QUATTROCCHI KWOK
ARCHITECTS

MEETING RECORD

Kofman Auditorium Dressing Rooms, ADA Observations

Project: Alameda High School – Kofman Auditorium
Systems Upgrades

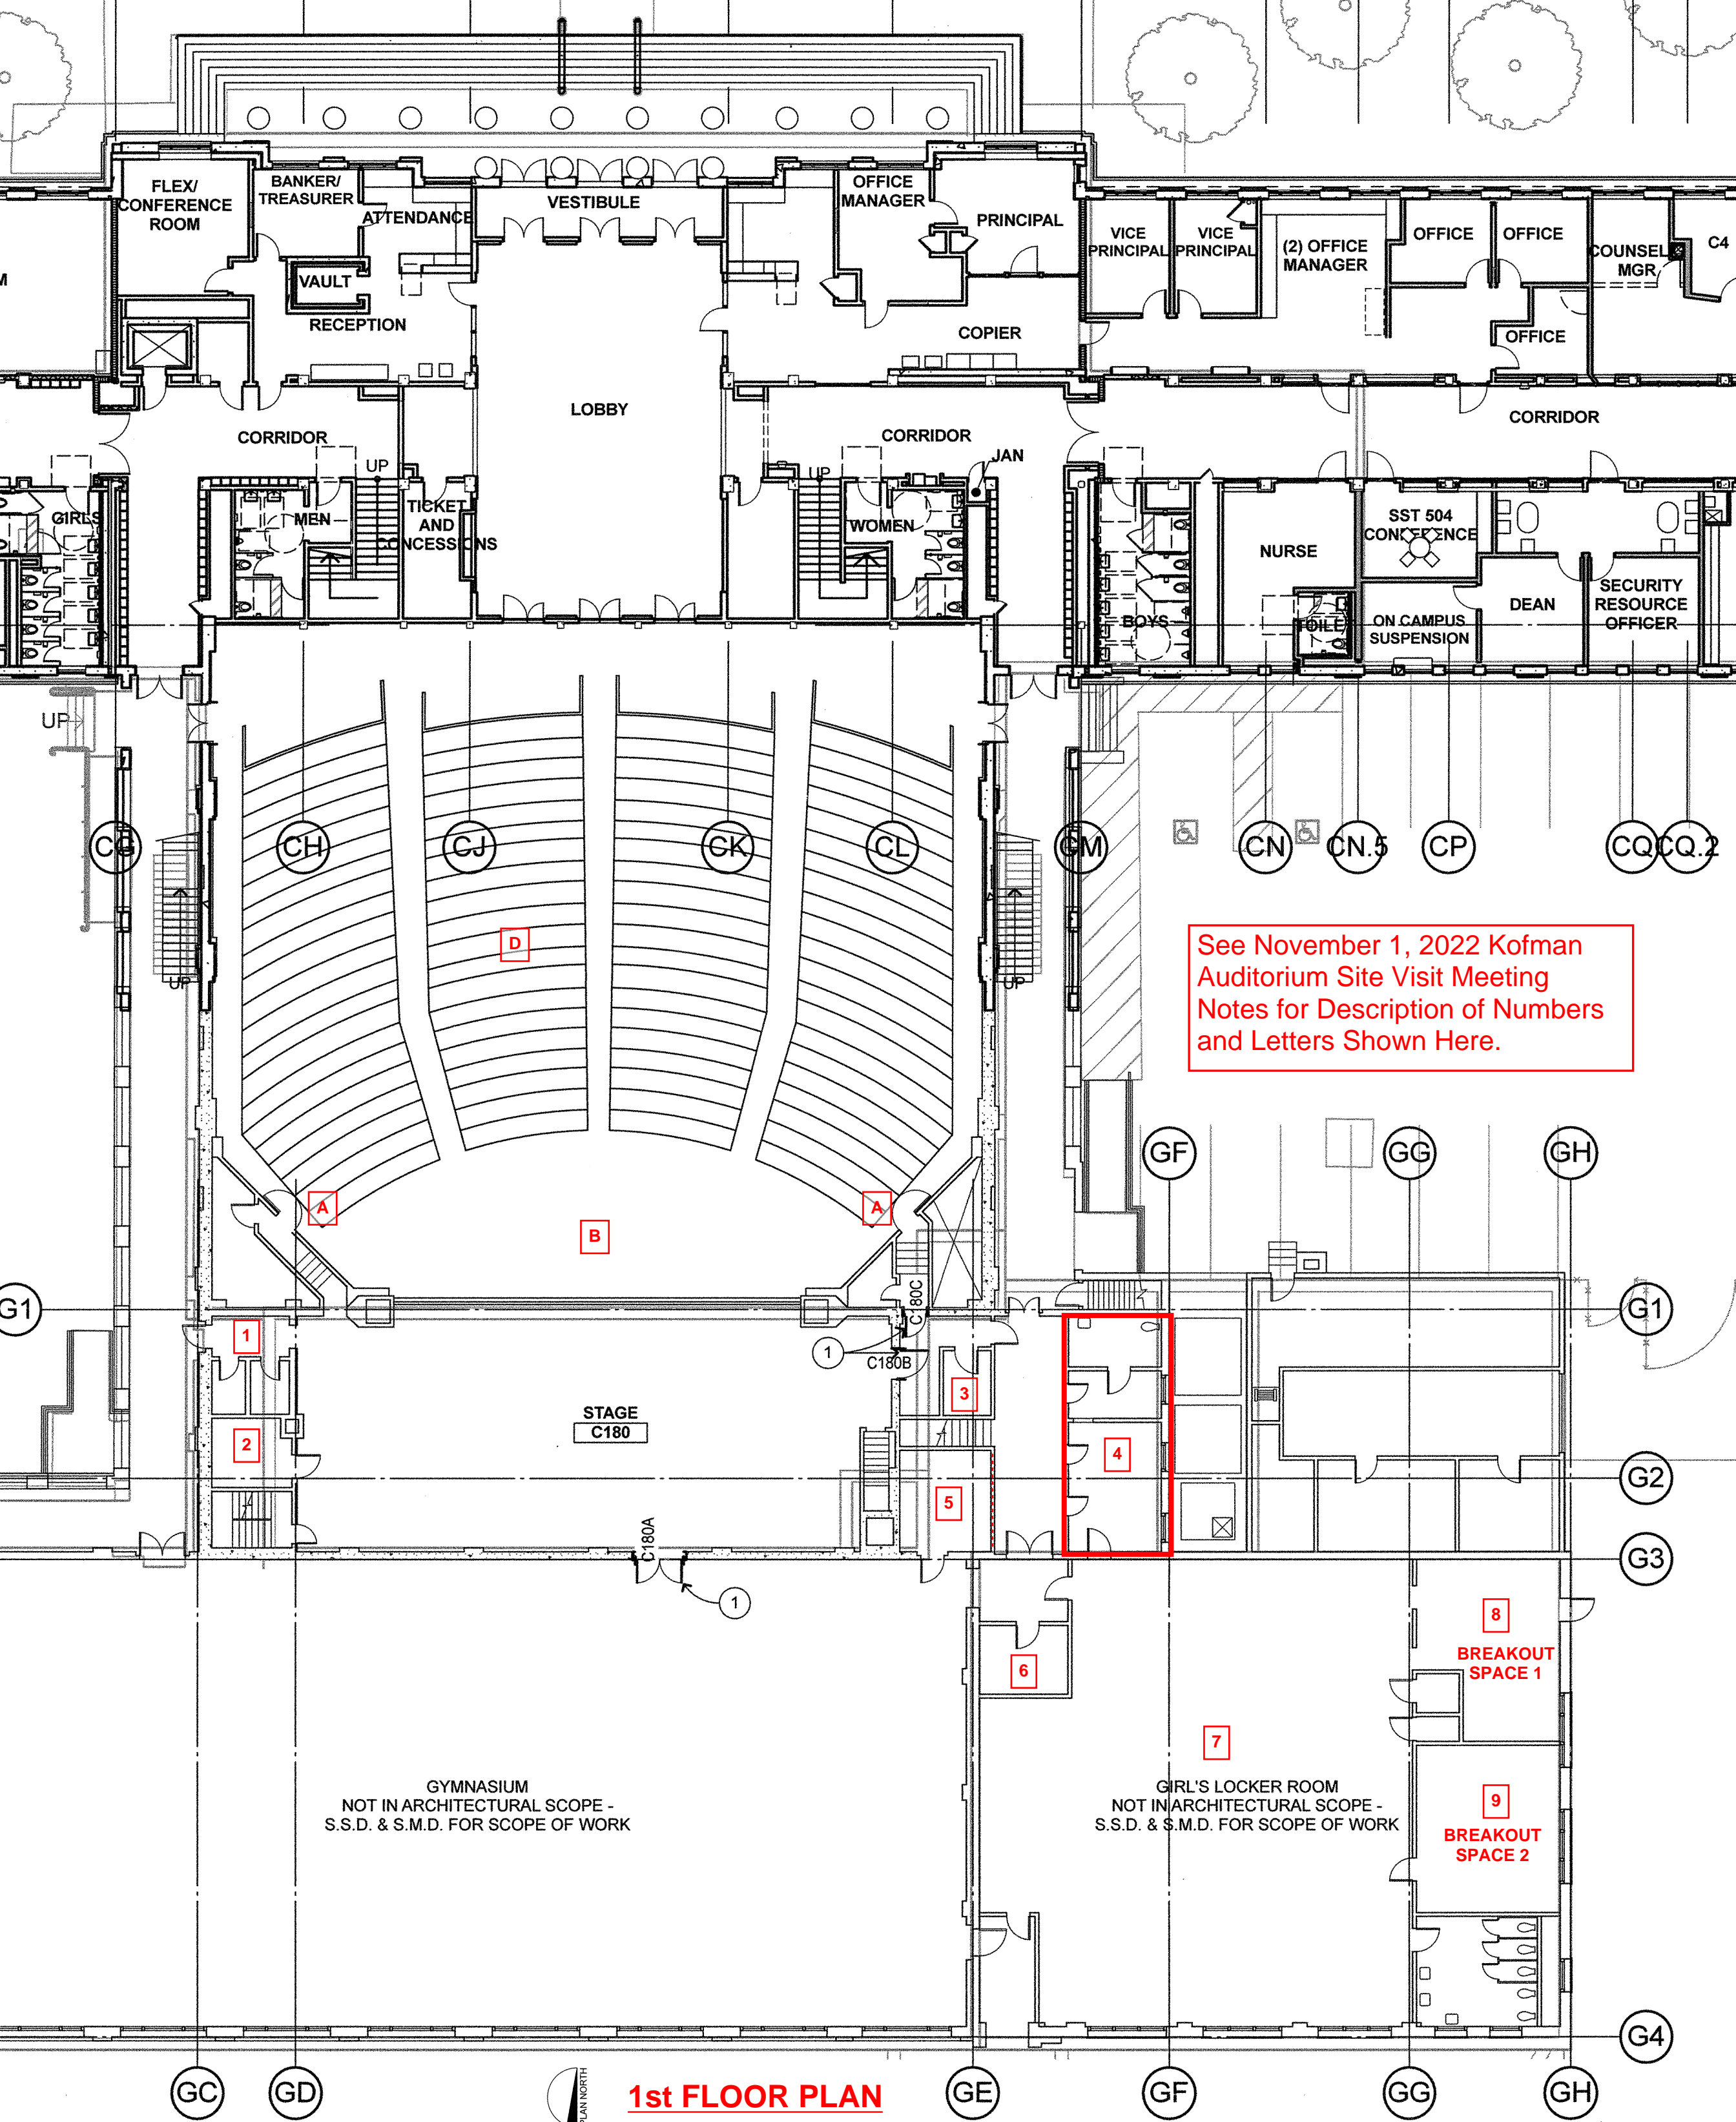
1. Existing dressing rooms w/ plumbing fixtures. Need replacement finishes & plumbing fixtures (if sinks in dressing rooms are desired).
2. Candidate for use as dressing room/s: Theater Manager's Office. SK stated that school is not planning to hire or keep on staff a theater manager. This space could be converted to dressing room/s to supplement keynote areas 1 & 3.

3. Like keynote area 1, this is an existing dressing room w/ a plumbing fixture. Similarly, would need replacement finishes & plumbing fixture (if needed).

4. Candidate for use as dressing rooms: Inspectors Rooms. These spaces are reserved for outside inspectors. SK suggested it may be possible to move them to another area/building/campus. These spaces have good proximity to the stage. One room appears to have plumbing as well (rooms were locked so was not able to access).

5. Candidate for use as dressing room/s: Storage Room. This space is being used for long term storage of Theater items that RI & SK agreed could be disposed of.

- a. There was a question as to whether the wall shown dashed used to have a door through it. Wall appears to be patched. Restoring that as an egress point to the hallway would benefit the space for dressing room use. Would need to study record drawings & code analysis.

6. Sports Equipment Storage. RI stated, the Gym needs to keep this space for storage, as they already have very limited space for storage.

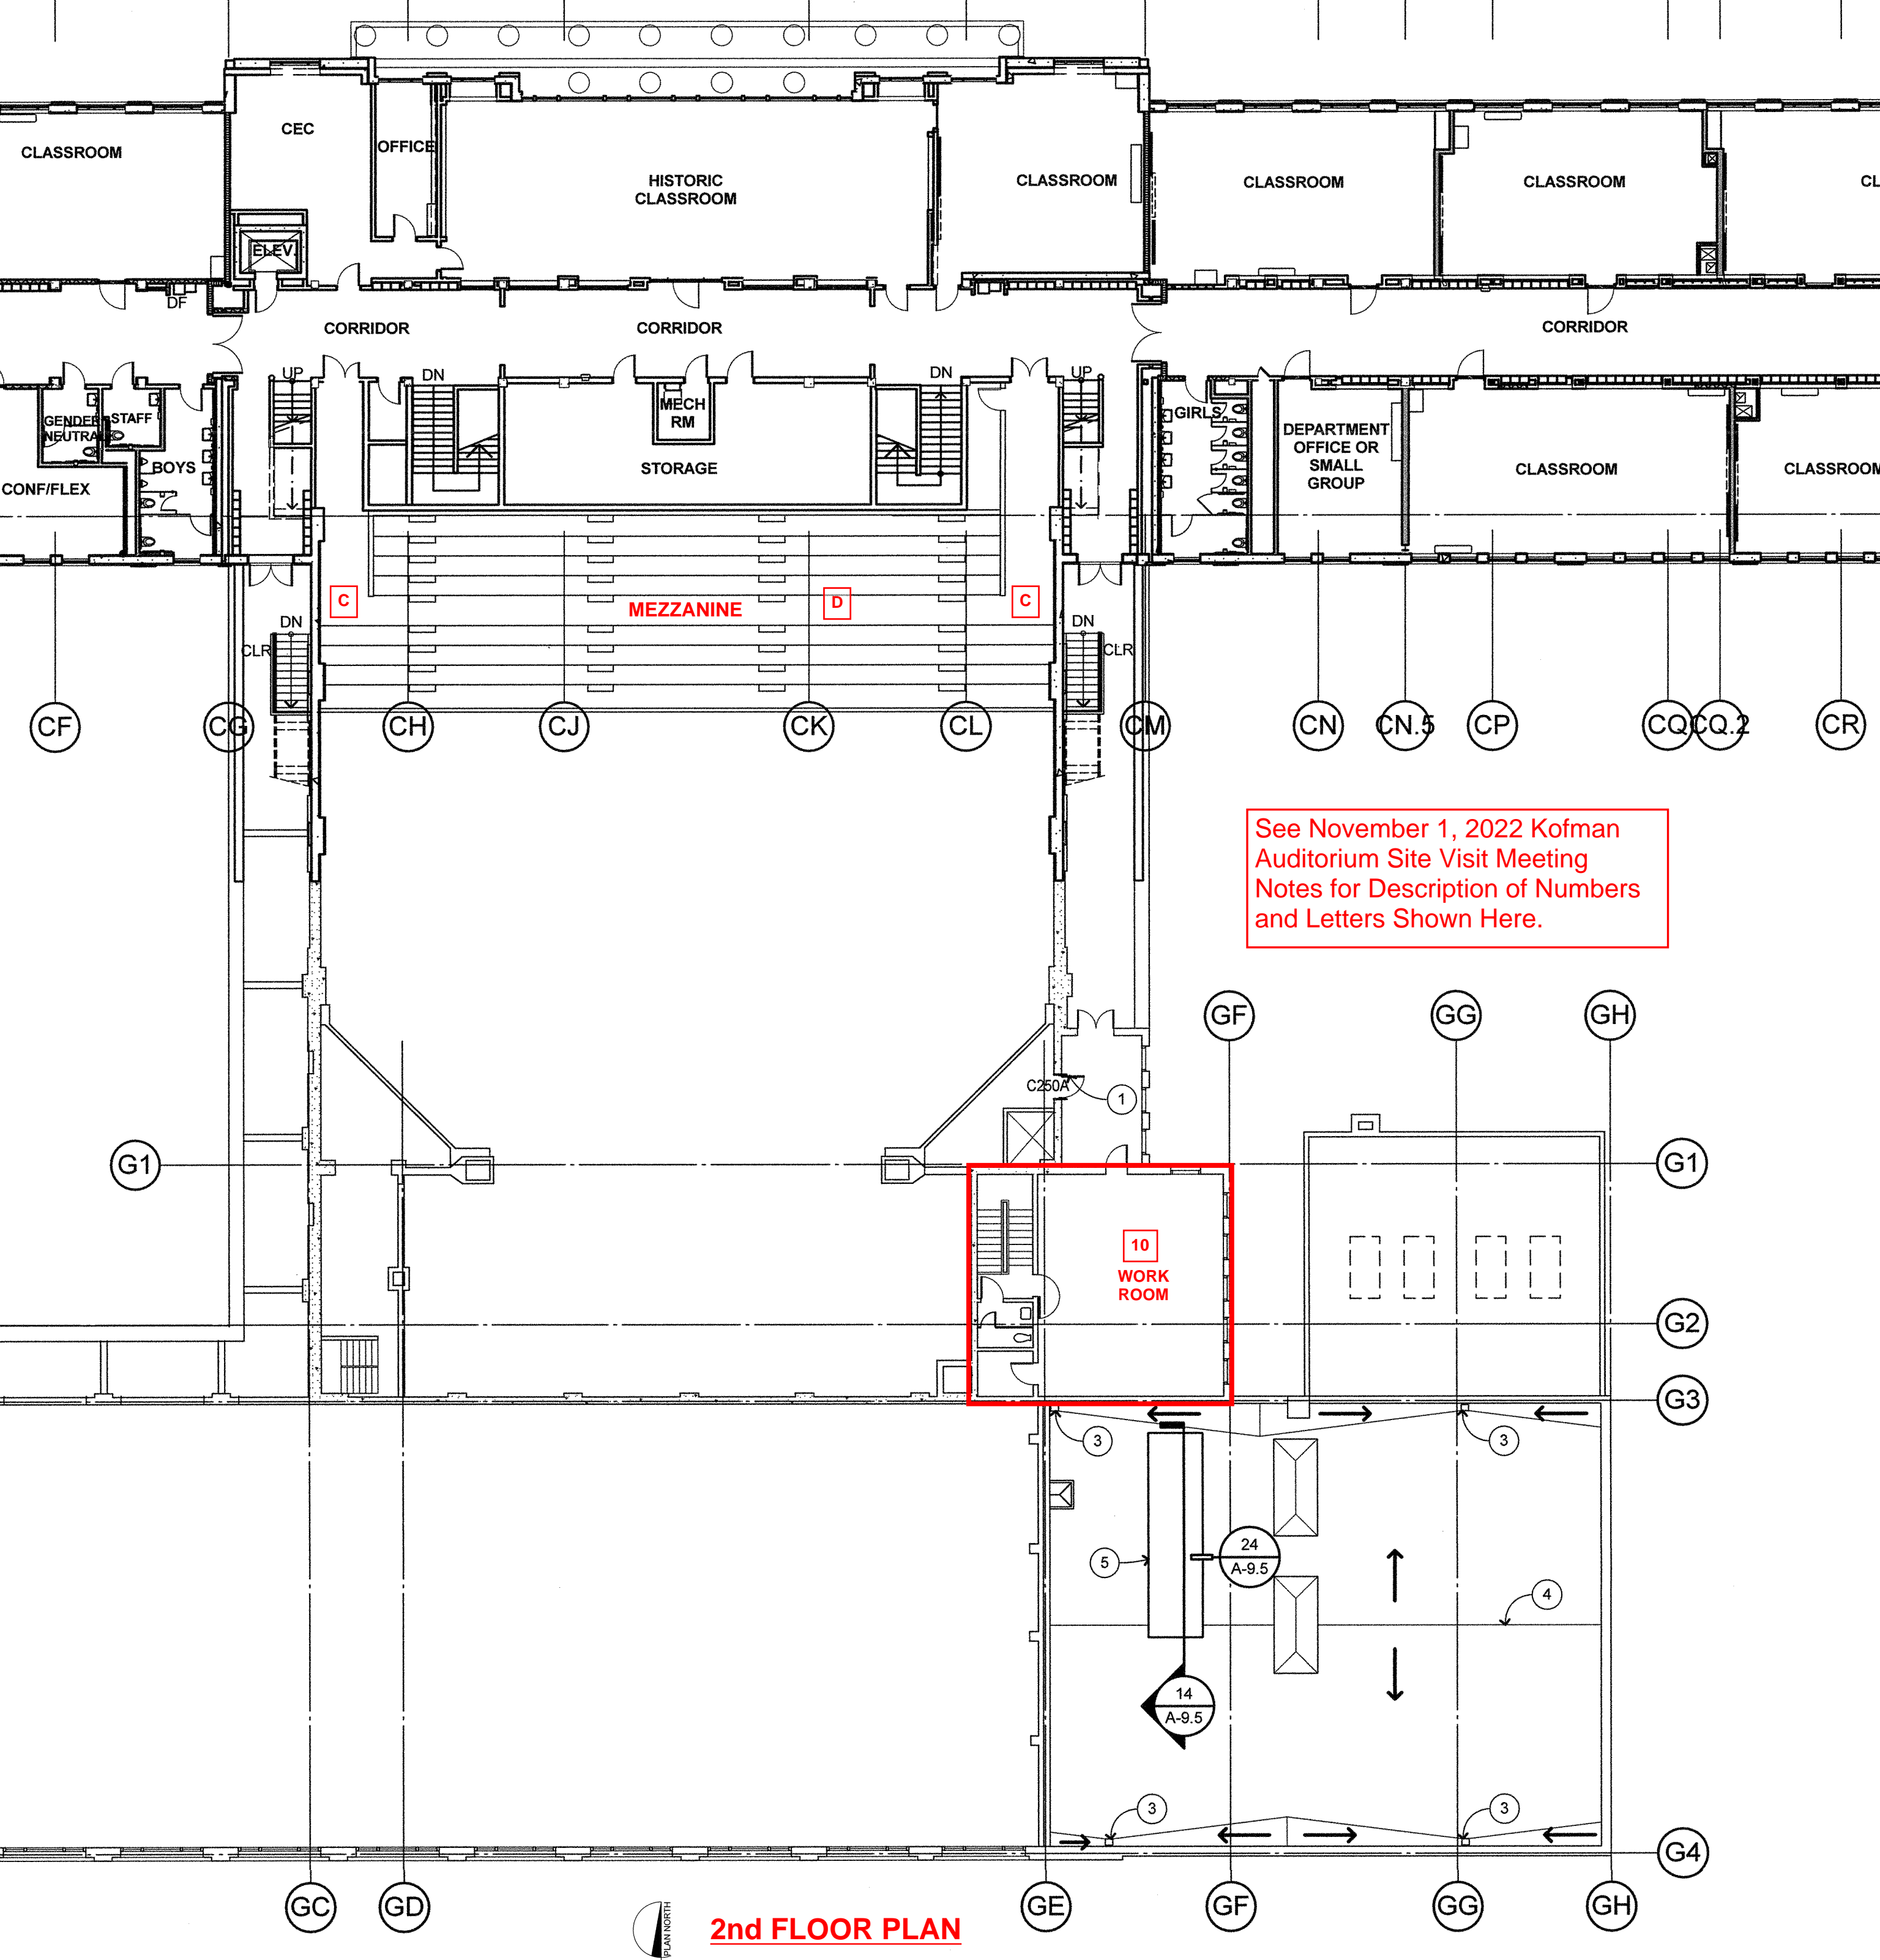
7. Martial Arts/Tumbling space. This large open space is well finished out for its current use. RI stated that sports message tables at south end of room could be moved to Breakout Space 2 (Keynote 9), and tumbling mats moved south to create more space on north side of room.

- a. If this newly created space was divided up by addition of partition walls into dressing rooms, that would most certainly need DSA review.
8. Breakout Space 1: Candidate for use as dressing room/s. The space might be used as overflow dressing room/s, in addition to using spaces at keynotes 1-5.

9. Breakout Space 2: Candidate for use as dressing room/s. This could also be used as an overflow dressing room, but Breakout Space 1 would likely work better programmatically. That way there is less intrusiveness between sports & theater activities.

10. 2nd Floor Work Room: Candidate for use as dressing room/s. This space is occupied by the district Construction Manager, though RI & SK suggested it may be possible to move them to another area/building/campus.

- a. There is a restroom off the same stair landing. This would be beneficial next to dressing rooms. RR is not ADA compliant though, would need to be reconfigured if this went through DSA.

- b. Since Work Room space is accessed by stairs, it would not be ADA accessible. Some dressing room space would still be needed on first floor. Inspector Spaces below (keynote 4) would be ideal to work in conjunction with this space above, to avoid equal facilitation conflicts.

2nd FLOOR PLAN

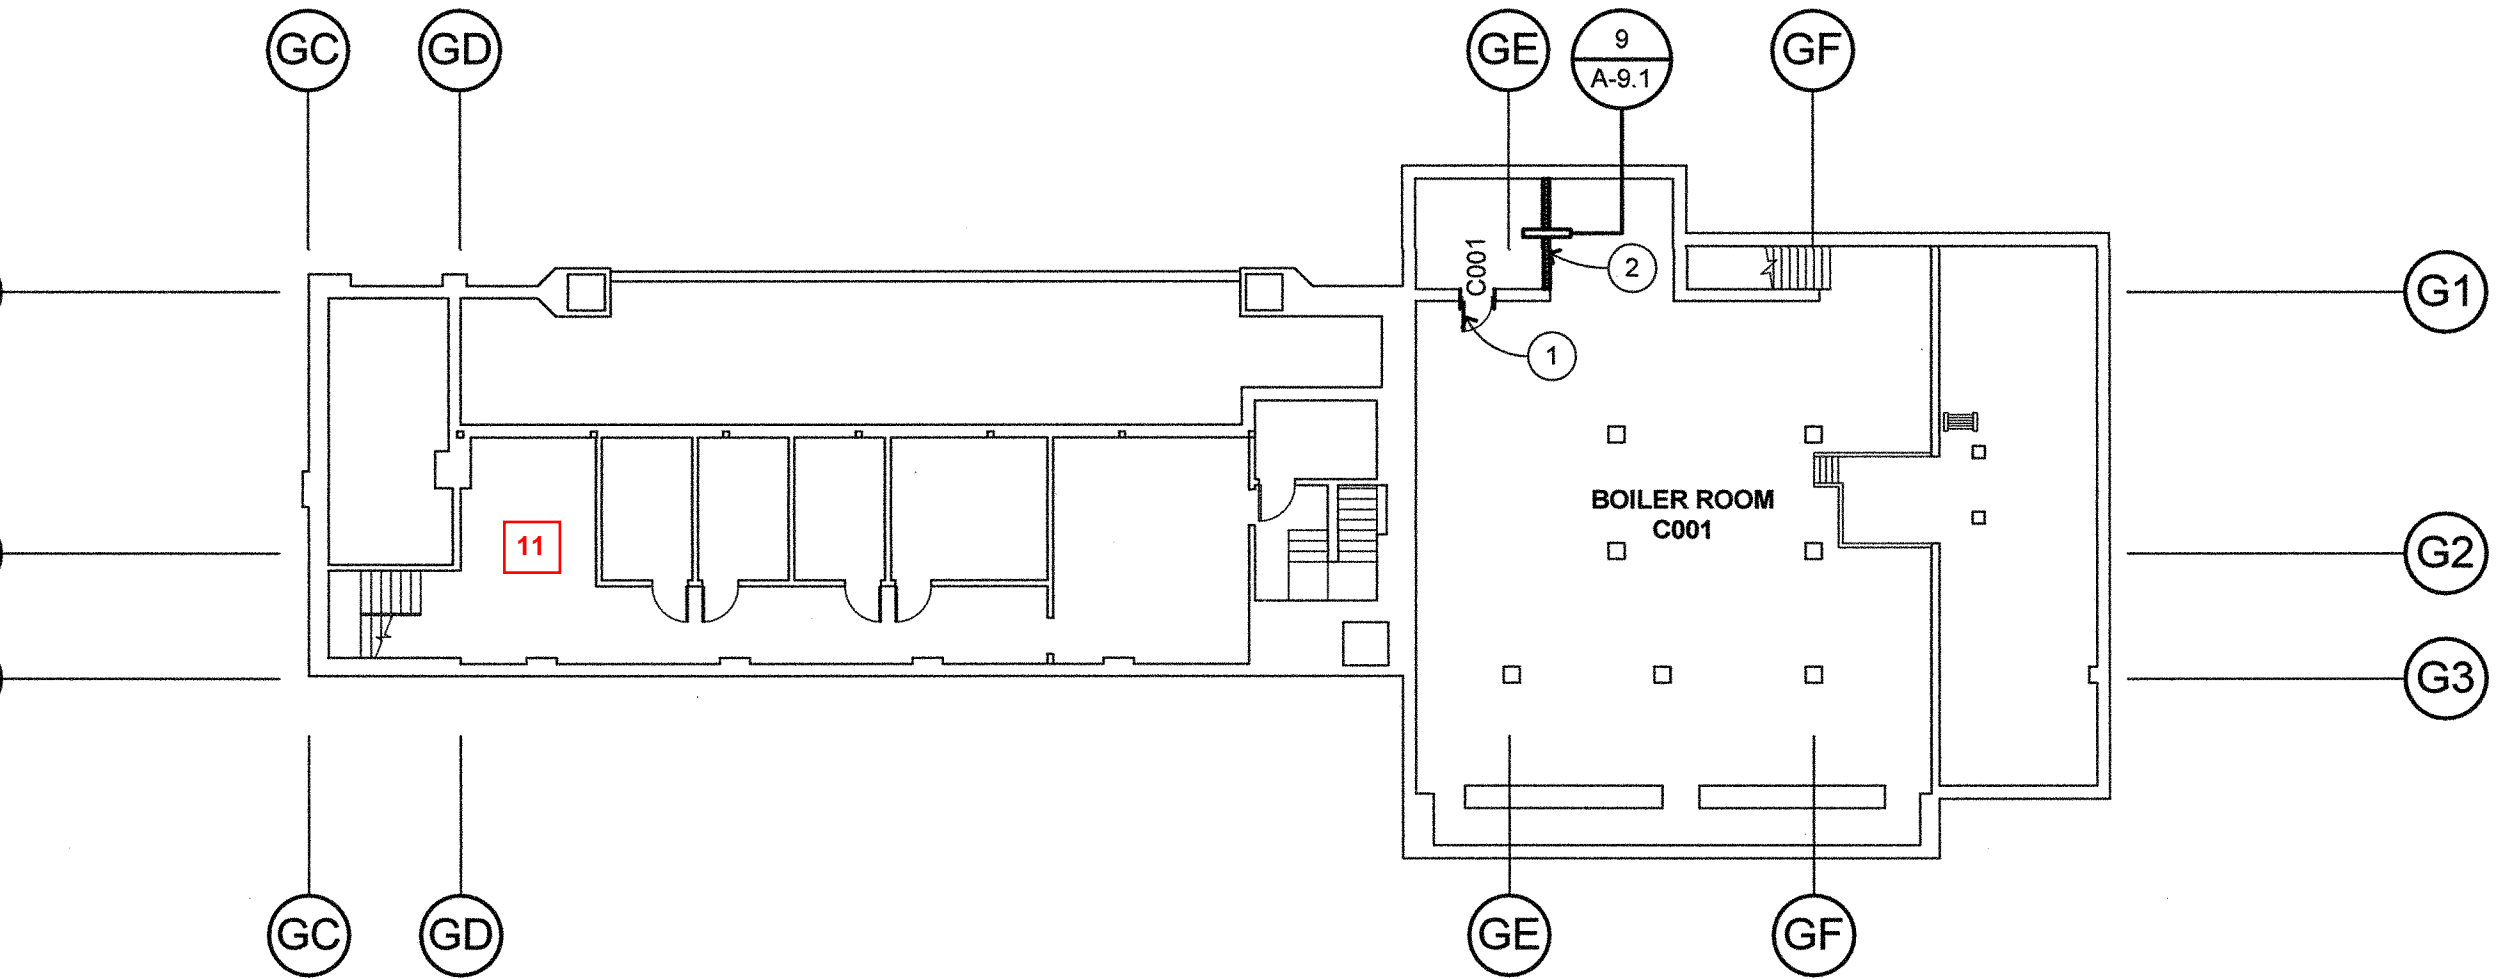
11. Below stage space previously used for dressing rooms. A fair amount of space, but in addition to ADA compliance issues that space might require HVAC work. Seems damp and very musty.
